Comments on NERC Draft GMD Standard TPL-007-1 – Overstatement of Peak dB/dt of Reference Waveform

Comments on NERC Draft GMD Standard TPL-007-1 – Problems with NERC Reference Disturbance and Comparison with More Severe Recent Storm Events

Unofficial Comment Form

Questions on Draft 1 of TPL-007-1

Figure 3: Historically observed geo-electric fields (Source: Storm Analysis Consultants).

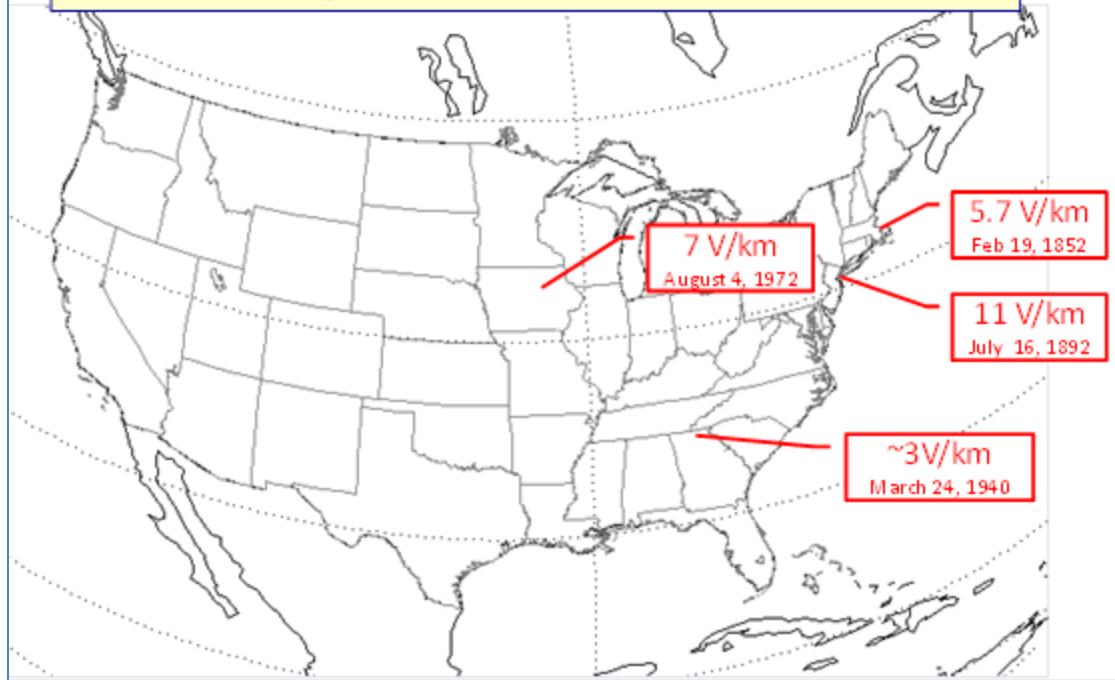
Figure 3 shows a small number of measured geoelectric field intensities, indicating date and location. As can be seen, the observed values of these storm intensities (which could represent “hot spots”), are near or above 8 V/km. Given that such field intensities have been measured previously, it is recommended that a larger benchmark event be used for evaluation of system resilience for GMD events, and it must be demonstrated that the benchmark event represents a reasonable “worst-case” scenario, and captures the geoelectric field intensities of known historical storms.
